AMD-K6[®]

Processor Revision Guide

Model 6

Publication # 21266 Rev: G Amendment/ 0 Issue Date: August 1998
--

Figure 1. AMD-K6[®] Processor Assertion of HLDA Due to Simultaneous BOFF#/HOLD Assertion

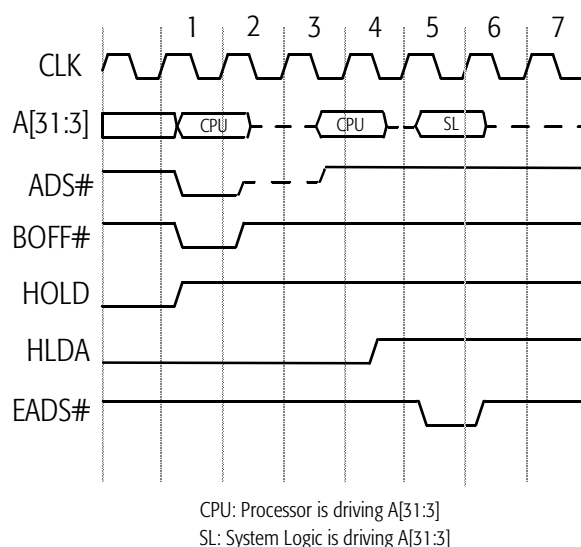
2.2.2 HLDA Assertion Delayed by One Clock

Non-conformance. If BOFF# and HOLD are sampled asserted on the same clock edge that negates ADS#, the processor asserts HLDA two clock edges after HOLD is sampled asserted.

Potential Effect on System. There are three potential effects of this erratum to consider:

- If the system logic asserts BOFF# for a duration of one clock, anticipates the assertion of HLDA in clock 3 (see Figure 1)—which is the normal specified operation—and drives the address bus and EADS# for an inquire cycle in clock 3, then the processor will not sample EADS# asserted. In addition, address bus contention will occur in clock 3.

- If the system logic asserts BOFF# for a duration of two clocks, anticipates the assertion of HLDA in clock 3, and drives the address bus and EADS# for an inquire cycle in clock 3, then the processor will not sample EADS# asserted. (No address bus contention occurs in this case.)

- If the system logic asserts BOFF# for a duration of one clock, anticipates the assertion of HLDA in clock 3, and drives the address bus and EADS# for an inquire cycle in clock 4, then address bus contention may occur in clock 4. (The processor will sample EADS# asserted in this case.)

If the processor does not sample EADS# asserted during an inquire cycle, cache/memory incoherency will occur. Address bus contention can affect the reliability of the processor and the system logic.

Suggested Workaround. The system logic must sample the assertion of HLDA before asserting EADS# and driving the address bus for an inquire cycle—as shown in clock 5 of Figure 1.

Resolution Status. AMD has determined that all Socket7 and Super7[™] chipsets operate as described in the aforementioned suggested workaround. Therefore, AMD has decided to defer the resolution of this erratum until deemed necessary.
